1. Introduction

The layout of the Southern Interchange Compound requires amendment to facilitate the transition of the site from a construction compound into the Motorway Control Centre (MCC) and requires layout amendments from that detailed within the initial and currently approved Ancillary Facility Management Plan (AFMP). There are a range of proposed amendments which are discussed below.

Attachment A – Revised Southern Interchange Compound Layout

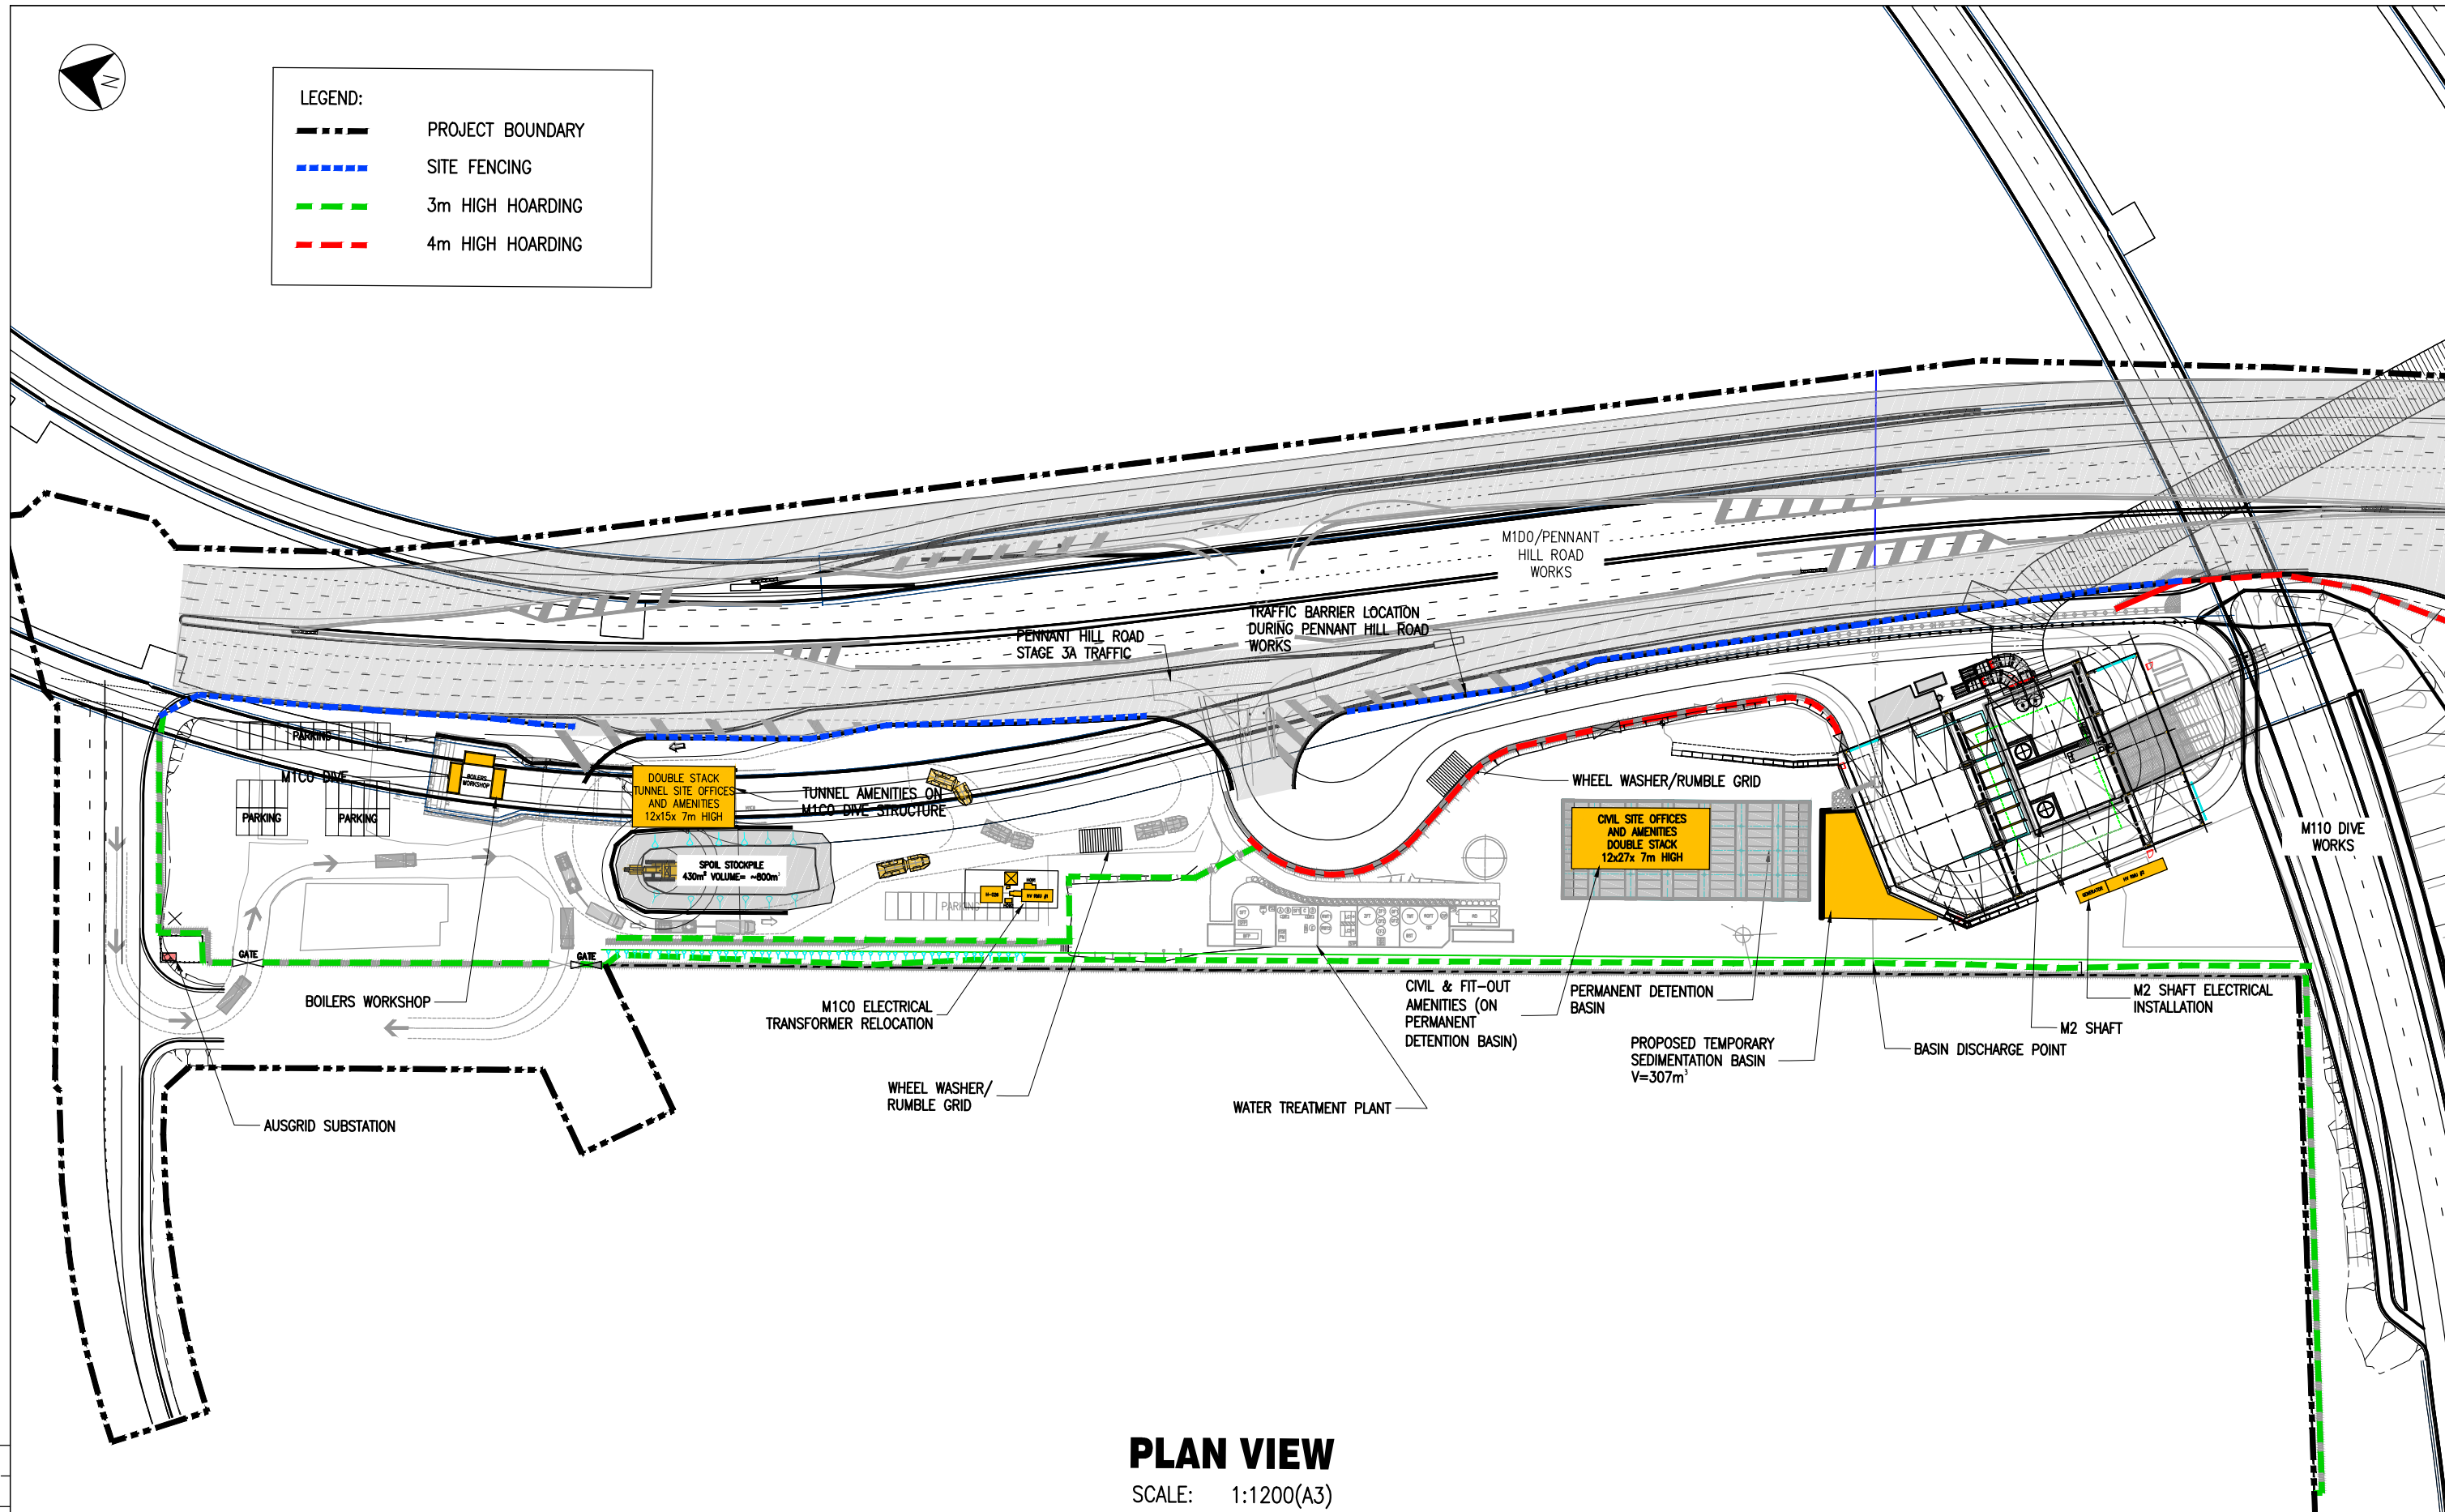
- Construction of a temporary sediment basin and the decommissioning of the old sediment basin to facilitate construction of the storm water detention tank.
- Relocation of Electrical Transformer and associated equipment.
- Relocation of Tunnel Office and amenities building to a location above the dive structure.
- Relocation of Civils Office and amenities building to above the storm water detention tank once it has been built.
- Relocation of the tunnel workshop to above the M1CO dive structure and establishment of suitable oil / water separation infrastructure / bunding.
- Removal of sediment basin associated with current workshop location.

The construction of the temporary sediment and associated amendments to the site drainage to continue to ensure that site water is directed to the new basin which will assist in ensuring that site water is captured and treated in a compliant manner.

The Civils and Tunnels offices and amenities buildings move away from the site boundaries and closer to Pennant Hills Road so noise and visual impacts will be reduced. Whilst the facilities may be on slightly higher ground, the positioning of the buildings closer to the road will see the existing hoarding having a greater effect on blocking the views from the neighboring residents.

The relocation of the electrical transformer and associated equipment away from the site boundary and behind the 3m noise hoardings will ensure that there are no increased impacts.

The relocation of the workshop to a location above the M1CO dive will increase the offset distance between the workshop and the local residents thus reducing noise impacts from that of the current situation.
